Access Compliance Report

Public Rights-of-Way

Intersection ID: 31594	Main Street: HIGH_WINDS_LN	Cross Street: WINDY_VALLEY_DR	Location: NE
ADA ID: 10803DE398A8	Ramp Type: PerpDiag	Initial Pass/Fail: Pass	Overall Compliance: No
Severity Score: 17.5			
Codes/Mitigation Info/Possible Solution		Field Measurements/Component Compliance

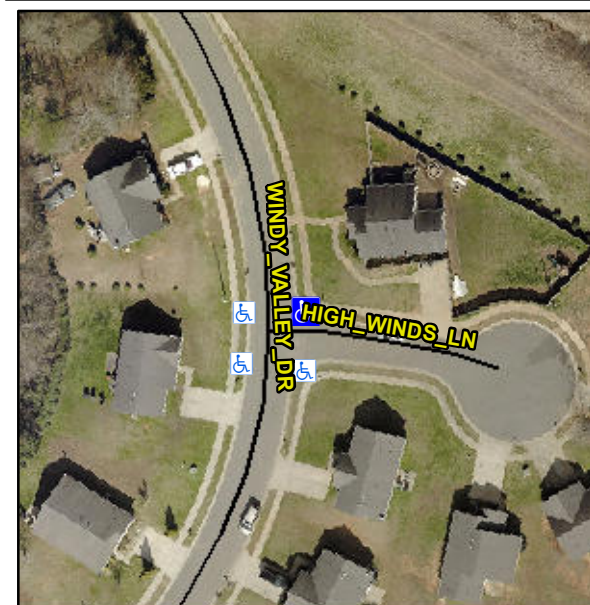
Not Found, R304.2.1, R305.1.4, R305.2, R302.7, R302.7.2

Remove & Replace Curb Ramp With Two New Directional Ramps or Equivalent.
